17 July 2024  
Our Ref: 20950D.6CE\_RFI

**Re: Development Application DA-2023/615 – Amended Plans and Additional Information  
4 Lindsay Evans Place, Dapto**

## 4.0 Response to Council's Request for Information

Figure 9 View from Stage 2 Community Hall towards Stage 3 to demonstrate that the lift overrun is mostly not visible from the street or public domain

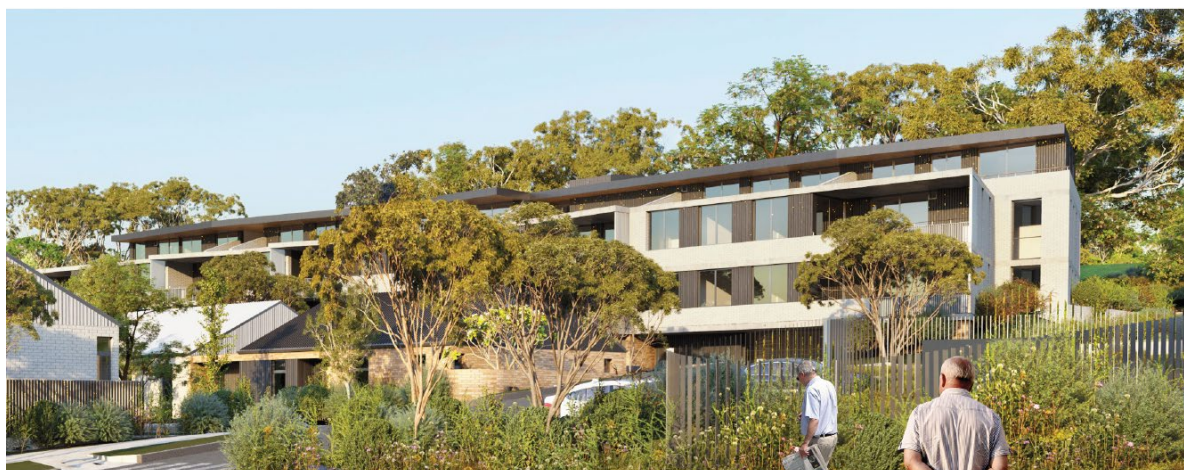
*The lift overruns of both ILU's along with the HW plant provided on the roof of Building A are not well integrated with the overall built form. Some variation in roof forms would likely improve this concealment of services and provide more visual interest to the overall building.*

The lift overrun has been designed to be recessive in bulk and perception and incorporates material and colour to the top floor façade. The lift overrun is in most cases not visible from the street or the public domain.

Figure 20 Redesign of northern villas

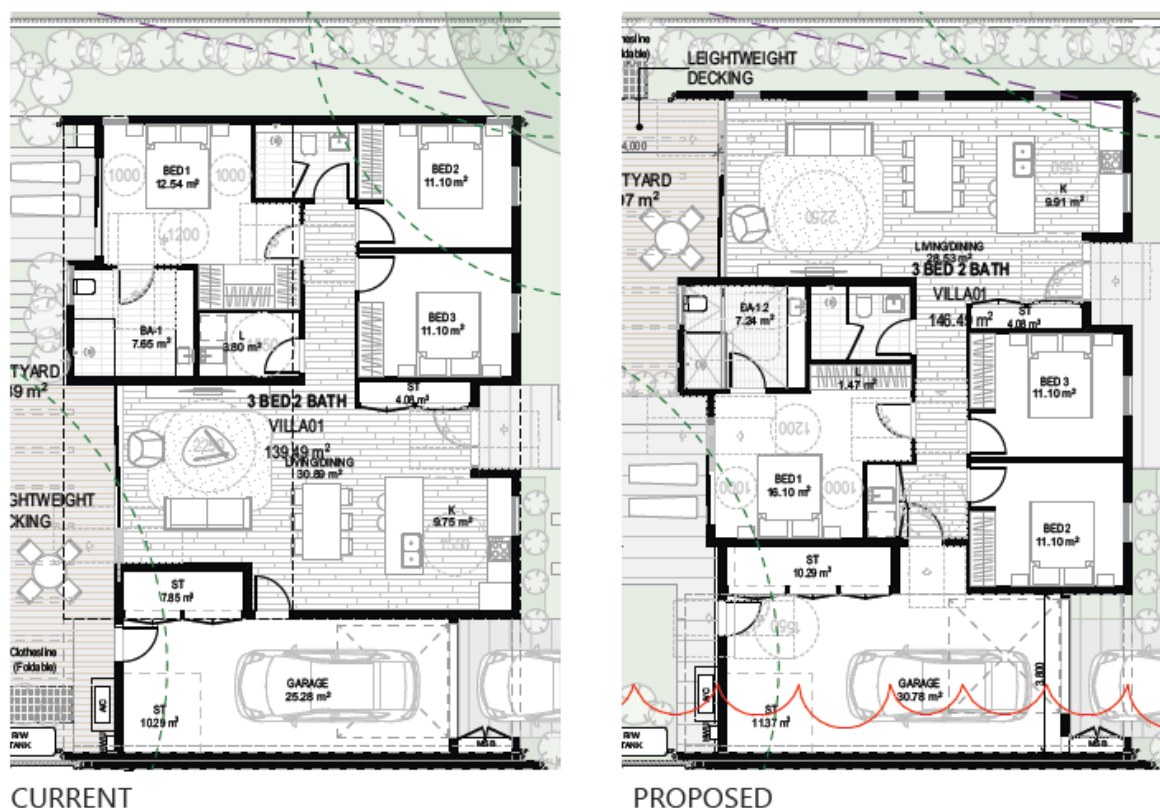
*The most northern and southern villas could be given a different treatment to create a point of difference and improve amenity. Living rooms could be re-orient (north and south) to provide an improved outlook and increased levels of natural light. This development will also allow the carport to be accessed via the circulation space servicing wet areas and bedrooms, rather than providing a door directly connecting the dining room to the carport.*

The northern villas have been redesigned to allow for the living areas to face north.

Figure 23 Section north-south of Building B

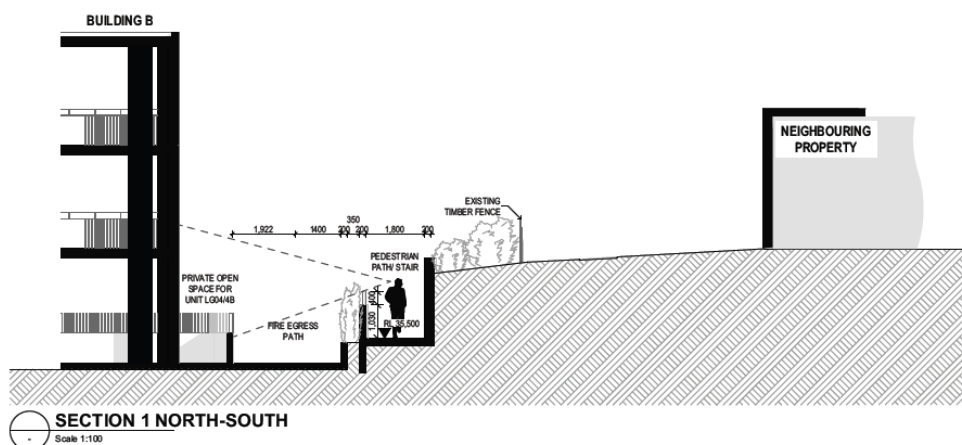
*The stair section provided on landscape drawing 2523003-803 clarifies the full extent of the cross fall of the site, however it would be beneficial to show the neighbouring properties beyond in a light greyed out graphic to better understand potential overlooking etc. It is also recommended that a large-scale detail plan be provided along with the section to better understand the exact location of the various elements (fences, planting, retaining walls etc) in relation to the northern boundary. A series of north-south cross sections should also be provided to better understand the relationship with the neighbouring properties, fence lines, retaining walls, landscape screening and the stairs themselves. The colour and finish of the retaining walls should also be noted on the drawings.*

Refer to sections below and detailed site plan prepared by Plus Architecture:

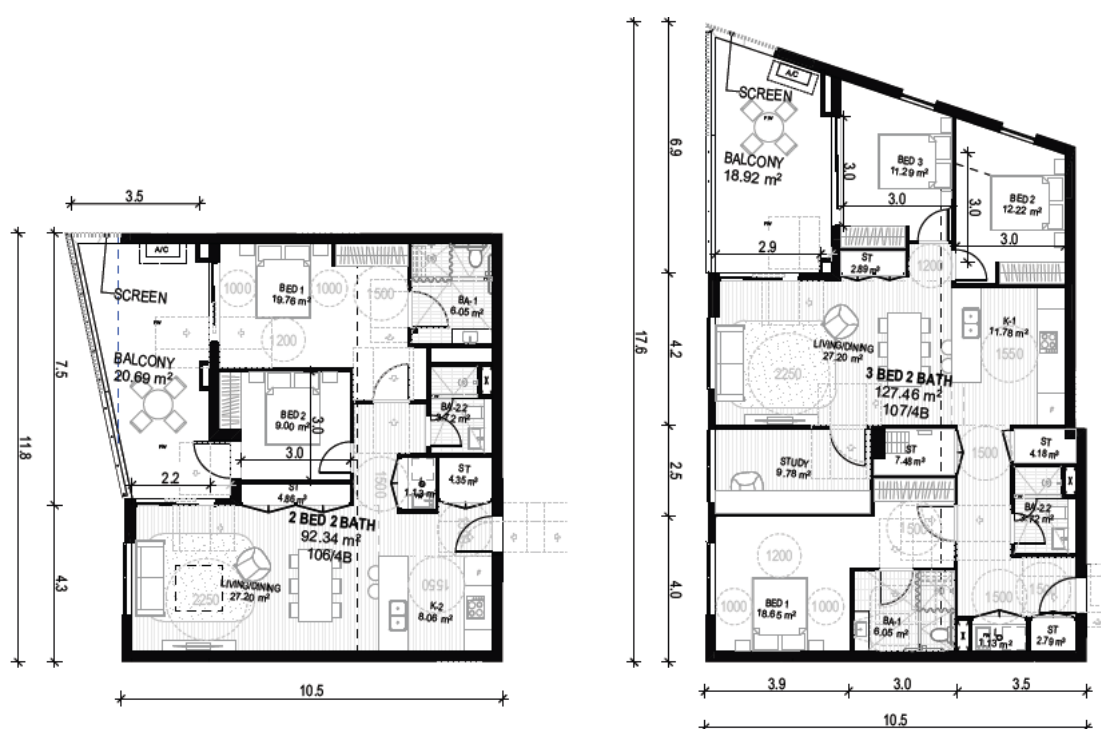
*ADG indicates that bathrooms and laundries should provide an openable window where possible. Some opportunities for this have not been explored (e.g. the ensuite in 205/4B)*

Windows have been included to the bathroom and laundries where possible. Please refer to typical plans on pages 87-92 of the Design report.

Figure 28 Indicative heights to POS

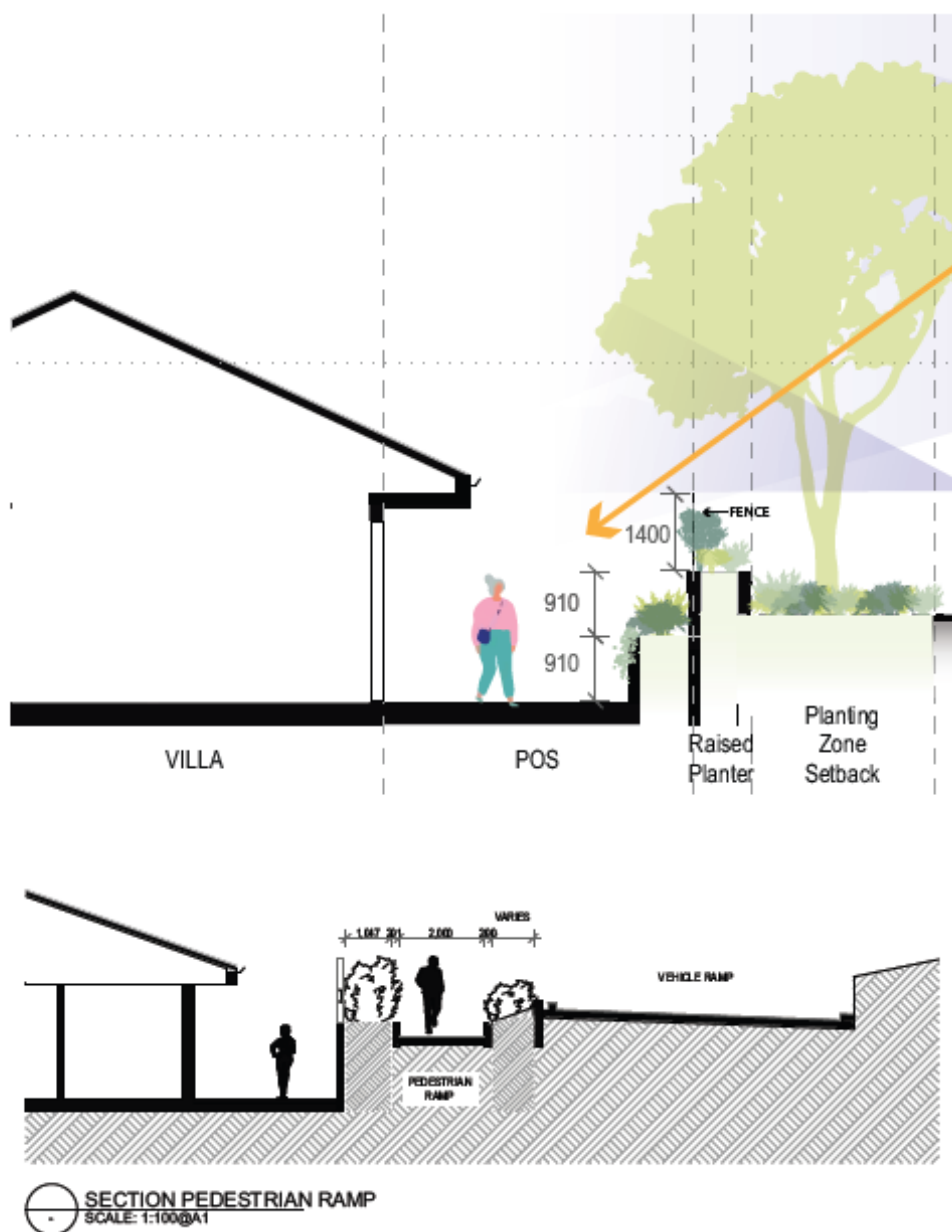
*The POS areas on the central row of villas are partially subterranean and heavily overlooked by the numerous west facing units in Building B. There is approximately a 1.7m height difference between the floor level of the villa POS and the adjacent COS space, which results in significant fence heights as viewed from the villas to ensure visual privacy and security can be maintained. It should also be noted that the section provided on landscape drawing 2523003-802 is inconsistent with the graphic representation of the landscape floor plans including the proposed location of the fence.*

The diagram below shows the indicative heights to the POS. The design has been reviewed and the section demonstrates minimal overlooking into the private open space which is mitigated by the 1.4m fence along the landscaping at ground level of Building B.

Figure 29 Revised door location to provide entry lobby to the carpark in Building B

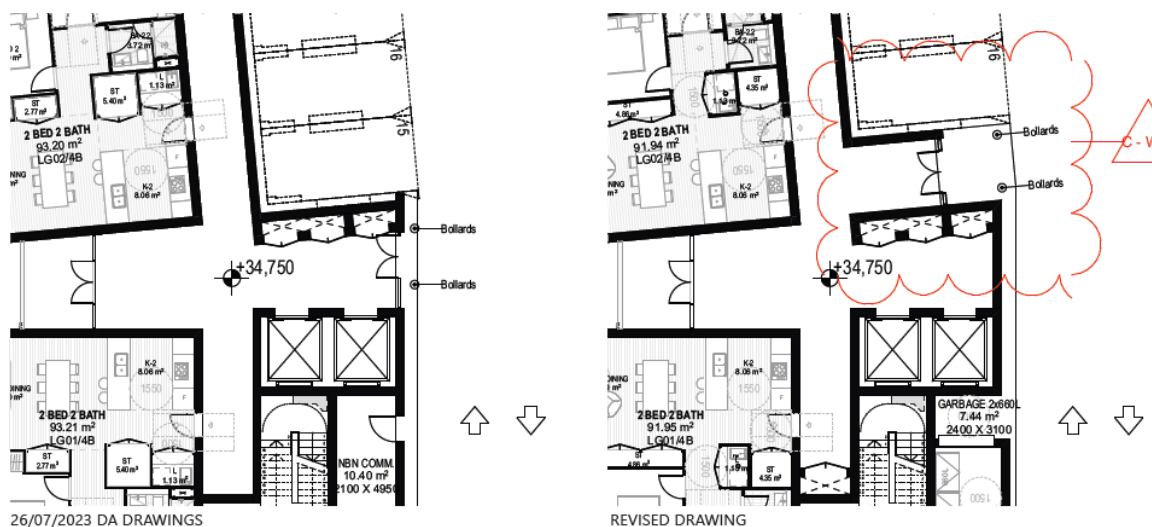
*The doors connecting Building B lobby from the basement carpark are located directly off an aisle which does not provide any refuge for pedestrians entering or exiting the lobby space. The location of the doors is to be reviewed.*

The door locations have been reviewed and amended to provide an entry lobby from the carpark to Building B residents.
